Olive Downs Coking Coal Project
Draft Environmental Impact Statement

Attachment 4
Peer Review Letters

Pembroke Olive Downs Pty Ltd
Olive Downs Coking Coal Project
Final Peer Review of HS
Groundwater Assessment and Modelling

Dr F. Kalf
B.Sc. M.App.Sc PhD
27 July 2018

Figure A. (From HS Figure 4-6) Section indicating dipping Leichardt and Vermont coal seams and outlined open pit extent to a final depth of about 0mAHD.

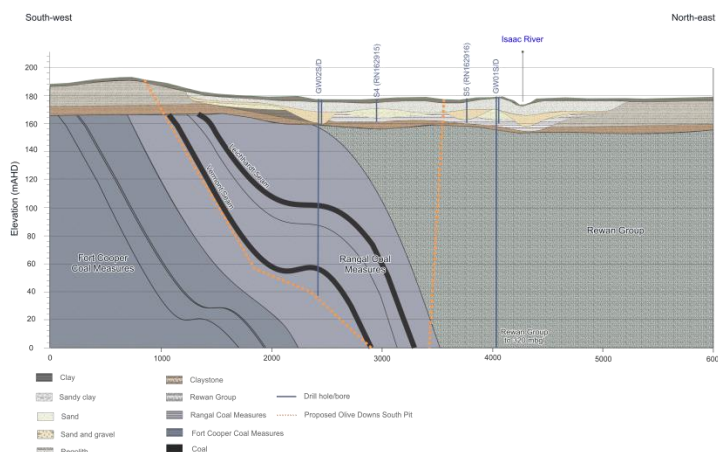
Conceptualisation for the HS model is considered suitable as shown in the sections of the syncline geological structure (Figure 5-34 and 5-35) (HS 2018).
